SUBJECT: WORN CARBURETOR INLET NEEDLE LEVERS**AFFECTS:** 240 CHAIN SAWS

Early Zama carburetors, used on the 240 chain saw, incorporated a plastic disc (see figure 1) underneath the main diaphragm to operate the fuel inlet needle. The 240 carburetor is mounted directly to the power head and the vibration causes the plastic disc to wear the lever.

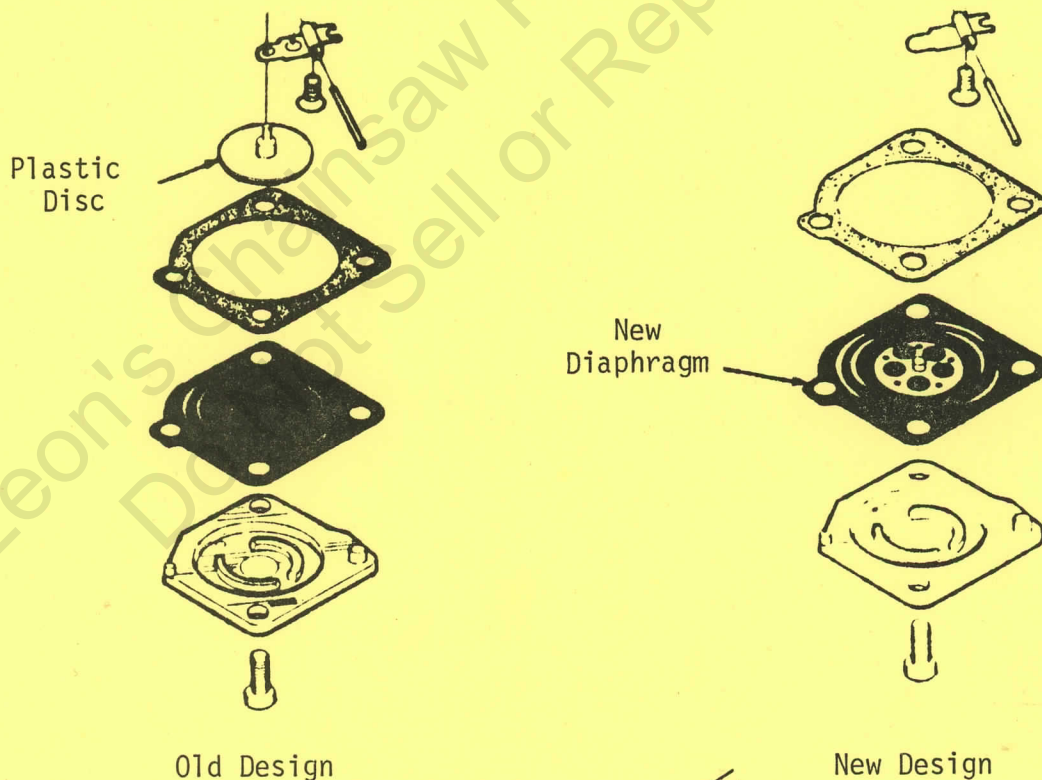
The plastic disc has been replaced by a diaphragm with a riveted metal disc, in order to prevent this wear. See figure 2. This improved diaphragm is available in repair kit 96646-A and carburetor A-96352-A.

INSTALLATION TOOL

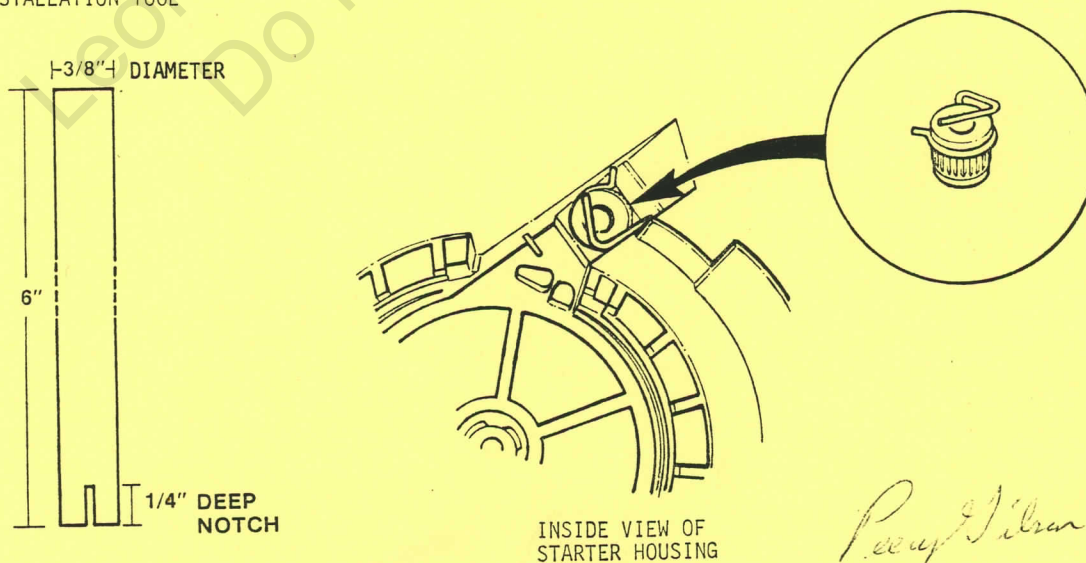
To install the bushing and guide kit in older string trimmer starter housings containing the small brass or steel bushing, drill through the existing bushing with a 3/8" (9,5mm) drill bit. Apply a quick set adhesive (Homelite part number 70627) to the bushing (with rope guide) and press it into the housing from the inside. Allow the adhesive to dry. This repair should not be made if the rope has worn a deep groove into the starter housing. In this case, replace the starter housing.

Refer to the diagram below for the proper assembly sequence and location of the bushing and rope guide. Assemble the rope guide onto the bushing (as shown in inset drawing) before installation in the starter housing. An installation tool (see diagram) can be made by using a 6" X 3/8" steel rod, bolt, or wooden dowel and cutting a 1/4" deep notch in one end.

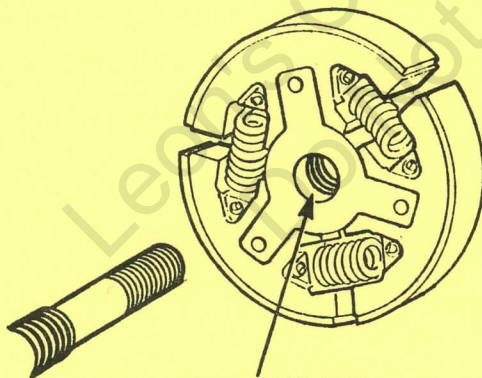
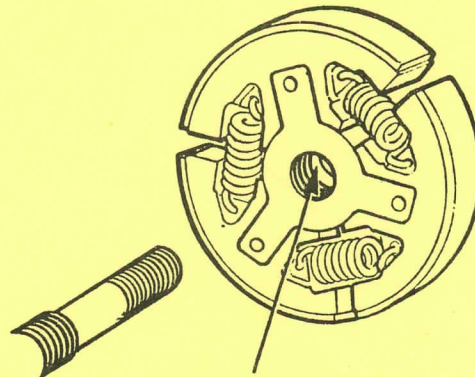
When installing a clutch assembly on any of the above units, the location of the counterbore (unthreaded portion of the center mounting hole) should be noted. Always install the clutch (left hand thread) with the counterbore facing towards the crankshaft (see diagram below*). If the clutch is installed backwards, crankshaft fatigue and failure could occur. Sprocket drum tolerances and saw chain alignment could also be affected.

Use the correct clutch tool (refer to unit parts list) and securely torque clutch to:

250 in.lbs. (28.2 Nm) - 330, XL-12, SXL-A0
125 in.lbs. (14.1 Nm) - XL, XL-2, Super-2, VI Super-2, ST-200

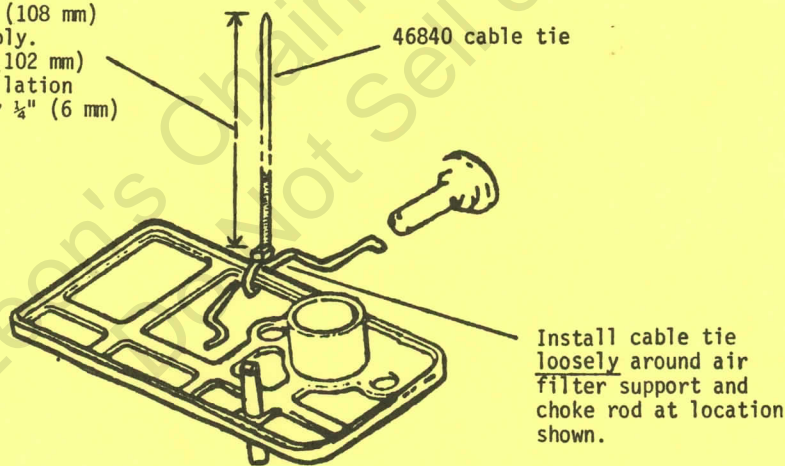
Reports have been received concerning some units of the subject model string trimmers being hard to start when cold. If this is the case, suspect the choke plate not closing completely.

This can be determined by removing the air filter and cover and inspecting the choke plate action. Should the choke close completely only when the choke knob is twisted slightly counterclockwise, improved choke action can be obtained by installing a cable tie (46840) loosely around the air filter support and choke rod (see diagram below).

This "field fix" will prevent the choke rod from falling down causing the linkage to bind, improving the action of the choke plate.

Excess length of cable tie should measure $4\frac{1}{2}$ " (108 mm) after assembly. Cut off 4" (102 mm) after installation so that only $\frac{1}{4}$ " (6 mm) extends.

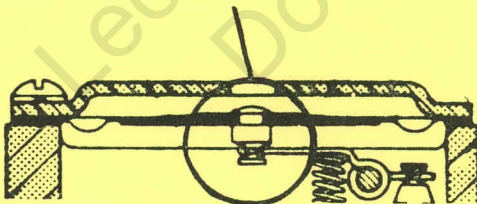
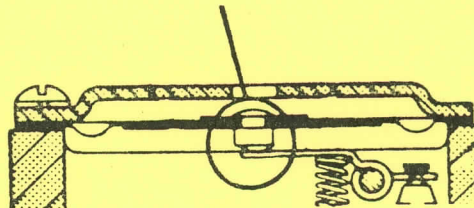
Any of the subject units built in early to mid 1984 (denoted by the letter "F" in the serial number) may be suspect of having an incorrect metering diaphragm in the carburetor. This non-captive diaphragm (see diagram) results in lower pop-off pressures for the inlet needle causing units to exhibit one or all of the following symptoms:

Diaphragm hooks
into inlet lever
(Captive)

Diaphragm button rests
on top of inlet lever
(Non-Captive)

The non-captive diaphragm should be replaced with a captive diaphragm (p/n 58988). Replacing the diaphragm only will be allowed under warranty by using the special warranty codes shown below:

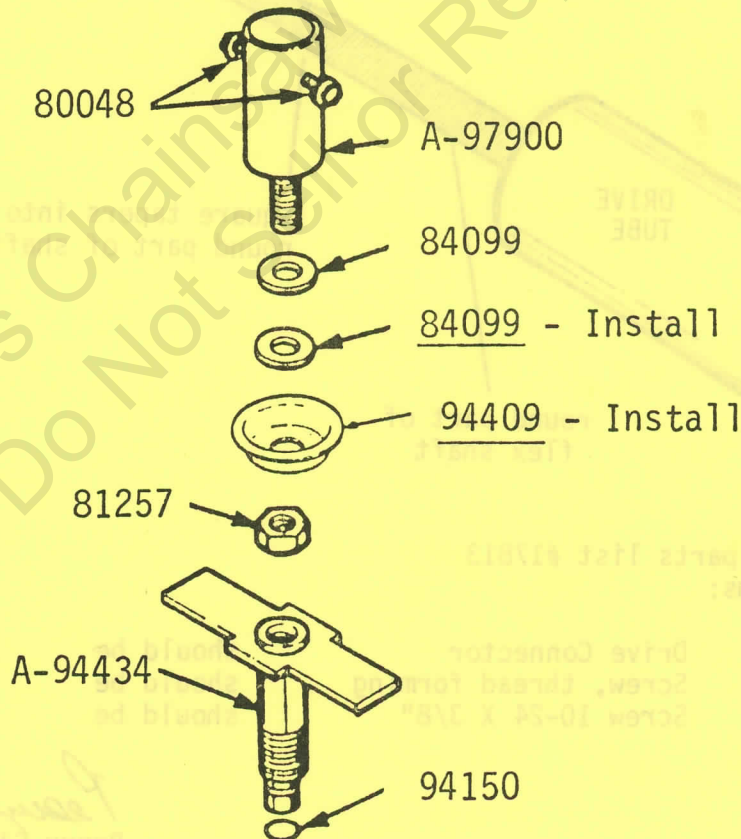
- 1) Whenever the lower head housing assembly (A-97900) is replaced on the subject model string trimmers, shield (94409) and a second flat washer (84099) should be added to the assembly (see diagram below). Addition of these two parts will prevent grass from wrapping around the shaft resulting in premature bearing failure. Without the above modification, early bearing failure can be expected to occur.

Use shaft holder tool (94482) to aid in the removal and installation of the drive connector and jam nut. Turn drive connector and jam nut clockwise (left hand thread) to remove.

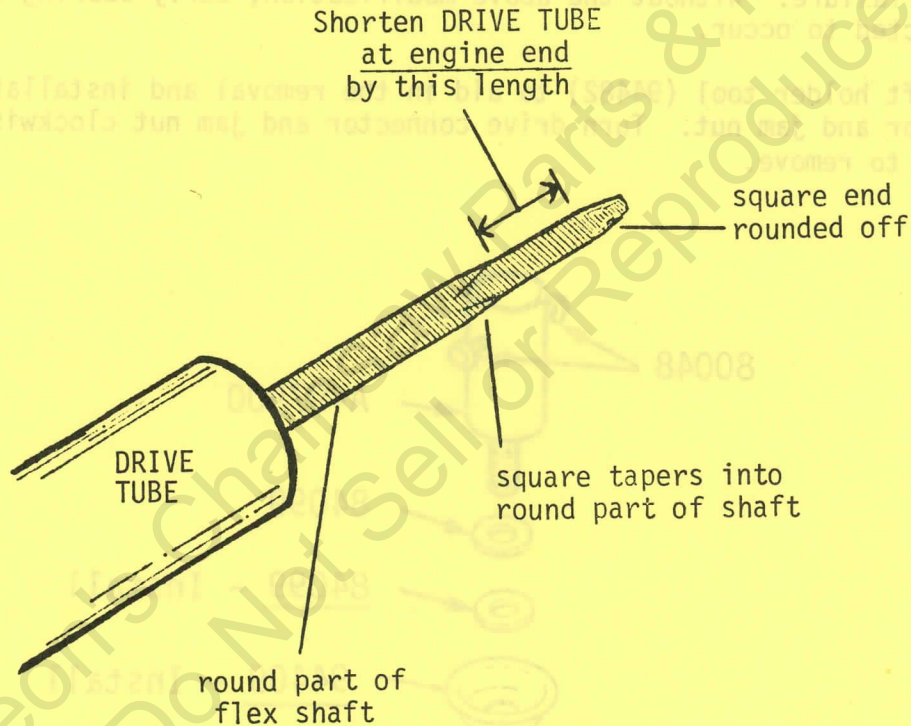
- 2) It has been reported that some drive tubes must be shortened to prevent the end of the flexible drive shaft from rounding off due to lack of full engagement in the square adapter. When this type of failure is encountered, the drive tube should be shortened (at the engine end) before reassembly with a new flex shaft or a similar failure will occur.

The length of the rounded off portion of the flex shaft indicates how much the shaft was engaging the adapter. The remaining, undamaged (not rounded off) length of the square determines how much the drive tube should be shortened to assure full engagement in the adapter.

Measure the undamaged length* of the square end as shown in the diagram below.
